JASIC Reply to ETRTO comments and questions on document WT-51-2

IWG WGWT
27th March 2023

JAPAN AUTOMOBILE STANDARDS INTERNATIONALIZATION CENTER

- **Slide 3:**

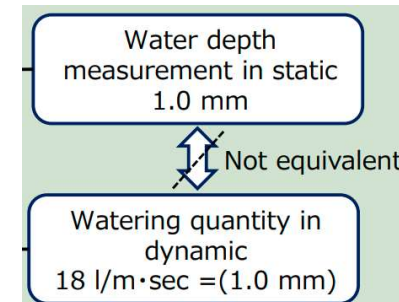
Roughness control at braking area.		
	Vehicle	Trailer
L	±5 m	±6 m
W	±0.5m

ETRTO need to understand from where the ±5m and ±6 m are coming from.

These are just an example of measurement point, from ISO 23671. To be determined after IWG discussion.
